SDP-24-05 – 414 S Main – V2 Submittal review cycle

START DATE: AUGUST 08-02-24	DUE DATE: <u> 09-09-24 </u>	TRC/STAFF Comments issued on: <u> 09/06/2024 </u>
------------------------------------	-------------------------------	---

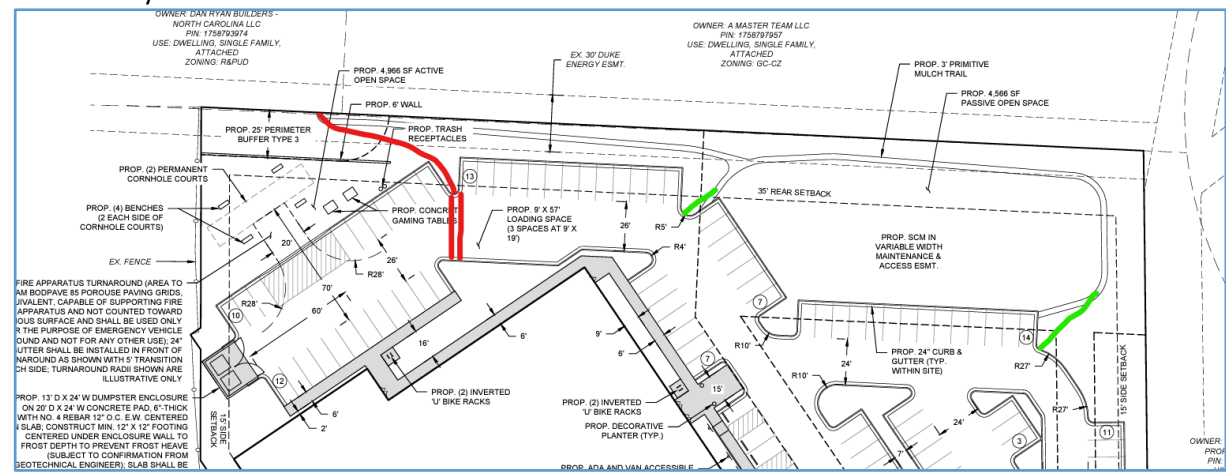
- Regarding pedestrian connections to the adjacent Townhome subdivision, see exhibit below:
1. Please construct the **RED** component as an all-weather pathway. The material, the width, the method of construction is all up to the Applicant as this is a voluntary element not required by the LDO; however it achieves greater Town policies of encouraging and enabling pedestrian connectivity from residential concentrations to activity centers (eliminating unnecessary vehicle trips).
 2. Please revise entrances/exits for mulch trail to increase pedestrian accessibility – See **GREEN** items.
 3. Provide Painted crosswalks/stripes across vehicle use areas (drive aisles of parking lot) from terminus of all pedestrian pathways to one another; Pedestrian pathway continuations and connections should be clear and obvious as they intersect and cross vehicle use areas.
